Hornsea Project Three
Offshore Wind Farm

Appendix 29 to Deadline I - Permanent Access Note for HVDC converter/HVAC substation

STAGE 1 ROAD SAFETY AUDIT

REPORT REF: CCE11A/JMJ/RSA1 October 2018

Drg no JNY8772-72 1:500@A1

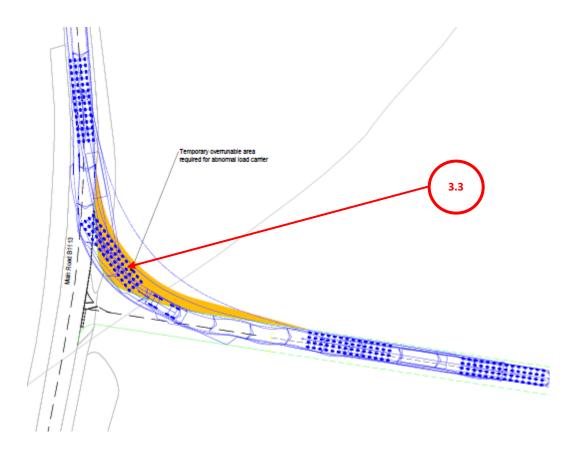
The drawing provided for audit does not give any detail of the proposed construction of the junction or temporary left turn overrun area; for example kerbing, pavement material and drainage. This could have a bearing on its safe operation, such as preventing verge encroachment and ponding/detritus on the highway. The latter is of particular importance as the site and access road are on a down gradient towards the junction, and this part of B1113 appears to be a low point with little positive drainage. Early consideration is advised.

4.8 The engineer agrees with CJ Safety Audit. An updated plan containing the proposed construction of the junction or temporary left turn overrun area; including kerbing, pavement material and drainage would be submitted prior to commencement of any work for approval.
